**Submission on Application for the Ksi Lisims LNG project on behalf of  
Douglas Channel Watch**

David Hughes  
Global Sustainability Research Inc.  
December 1, 2023

David Hughes, December 1, 2023

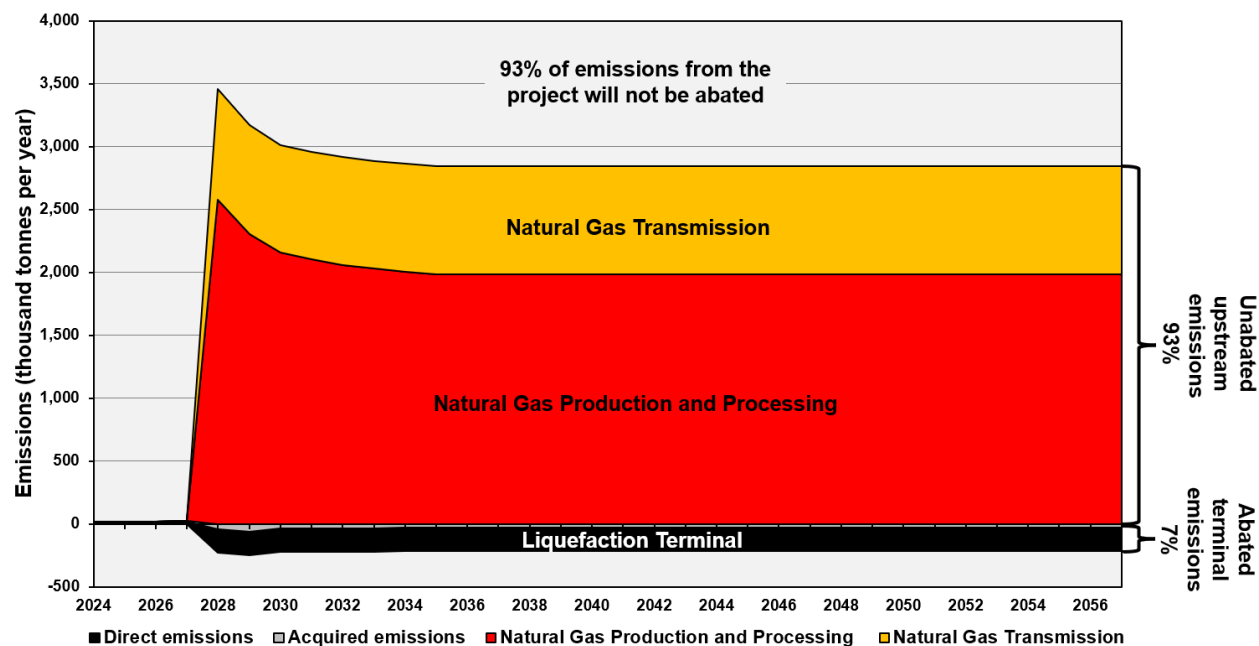
Emissions from the Project are tabulated in the Strategic Assessment of Climate Change volume of the Project’s documentation and are illustrated in Figure 7.<sup>13</sup> Although 93% of the Project’s emissions occur upstream of the liquefaction terminal to produce, process and transport the natural gas required, only liquefaction terminal emissions are considered in the B.C. government’s regulation requiring LNG projects to be net-zero by 2030.<sup>14</sup>

Figure 7 – Emissions from the Ksi Lisims LNG project from upstream natural gas production, processing and transportation, and from the liquefaction terminal using the Base Case in the application materials.<sup>13</sup> Only emissions from the liquefaction terminal are required to be abated by the B.C. government’s net-zero regulation, which means that 93% of emissions from the Project will not be abated.

Upstream emissions from the Project would accelerate climate change and diminish Canada’s chances of meeting its net-zero mandate. These emissions are clearly incremental to what would be emitted if the Project were not built, and are outside the boundaries of pathways to meet Canada’s net-zero mandate defined by CER’s net-zero scenarios. The Project’s proponents
